SUNDRY NOTICES AND REPORTS ON WELLS

1. Type of Well				8. Well Name and No.	
☑ Oil Well ☐ Gas Well ☐ Oth	ner	JAN.	16 2019	ANTIETAM 9 FED (COM 715H
Name of Operator EOG RESOURCES INCORPO	Contact: SARAH MIT DRATEDE-Mail: sarah_mitchell@eogresc	CHELL		9. API Well No.	
3a. Address		o. (include are accorde)	PEVE	0. Field and Pool or Exploratory Area	
MIDLAND, TX 79702	Ph: 432-8	48-9133		RED HILLS

Revised Permit Information 12/11/18:

Well Name: Antietam 9 Fed Com No. 715H

Proposed Wellbore

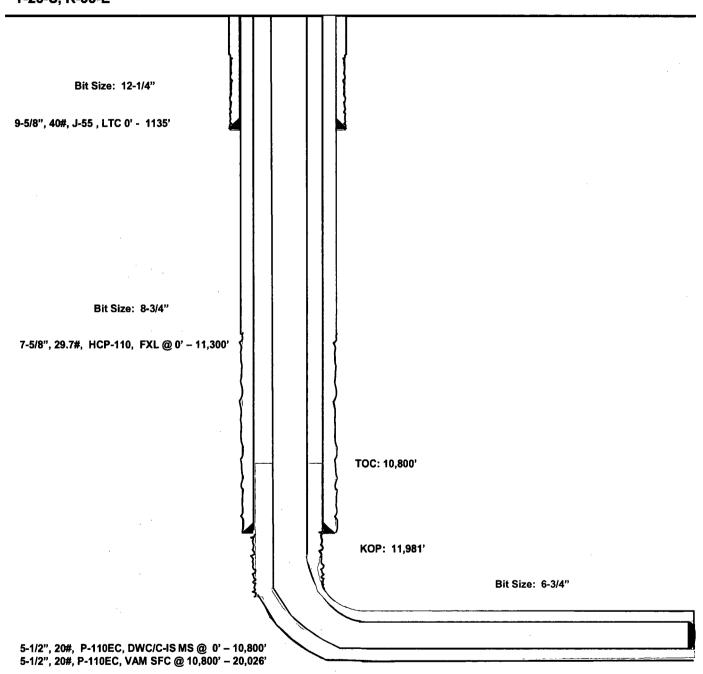
Variance is requested to wave the centralizer requirements for the 7-5/8" FJ casing in the 8-3/4" hole size. An expansion additive will be utilized, in the cement slurry, for the entire length of the 8-3/4" hole interval to maximize cement bond and zonal isolation.

Variance is also requested to wave any centralizer requirements for the 5-1/2" FJ casing in the 6-3/4" hole size. An expansion additive will be utilized, in the cement slurry, for the entire length of the 6-3/4" hole interval to maximize cement bond and zonal isolation.
